Service Bulletin No. 064

Alternator Model ALV-9610 Series Through Bolt Inspection for Proper Torque

Figure 1 - Typical ALV-9610 Alternator

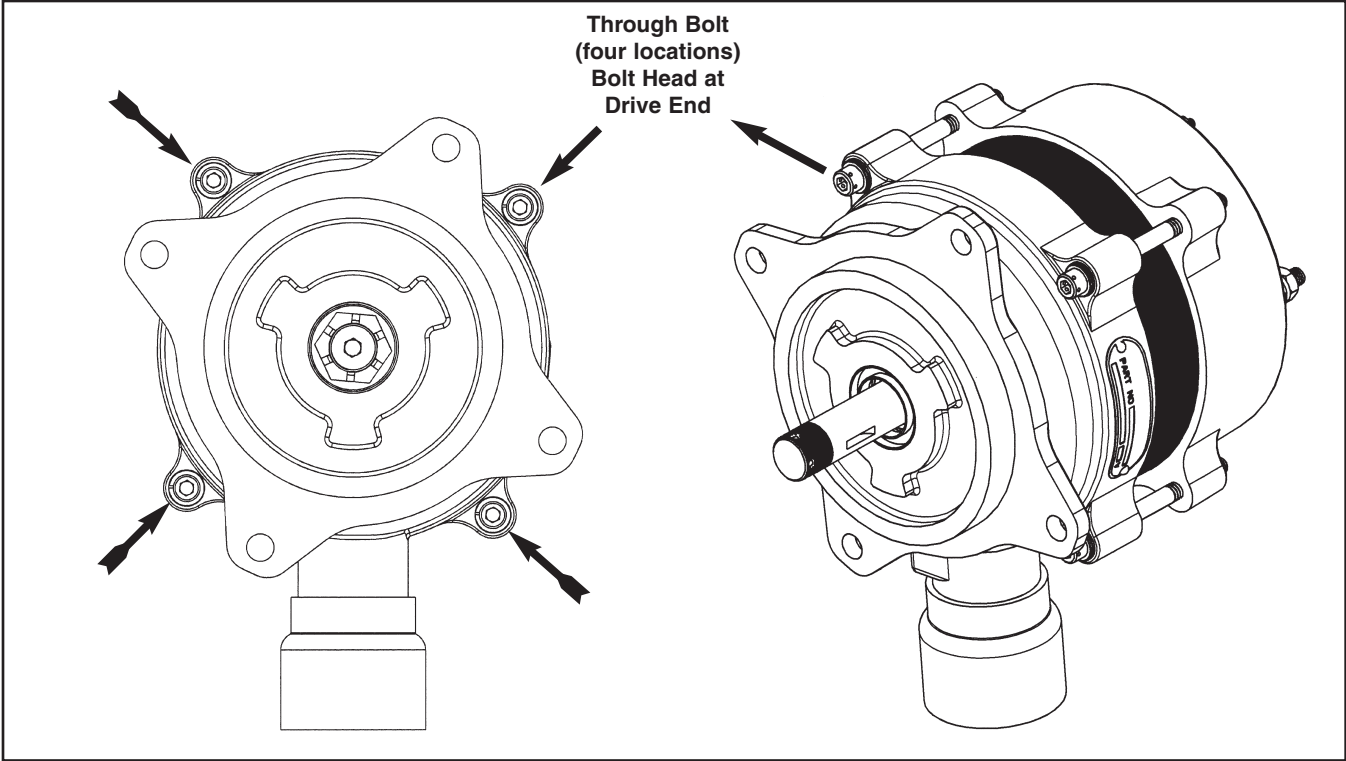
- (1) Affected alternator model ALV-9610 may have a condition where the flat washers under the through bolts impinge upon a cast fillet radius in the alternator housing through bolt boss. This condition may result in loss of through bolt torque.
- (2) An inspection to determine applicability of the ALV-9610 alternator and re-torque of each of the four through bolts if applicable, is required.
- (3) Regulatory action is unknown.

- (1) Remove the safety wire or safety cable from the head of the through bolts of the affected alternator. Refer to Figure 1.

- (2) Using a 3/16 hex stock tool, torque the through bolts to 45 to 50 in-lbs one at a time in a cross pattern using a calibrated torque wrench.
- (3) Properly install .032 inch stainless steel safety wire or optional Safety-T-Cable™, HET P/N RX-1961 at the head of the through bolts. Tool requirements and Installation information for Safety-T-Cable™ may be found at <http://www.dmctools.com>.
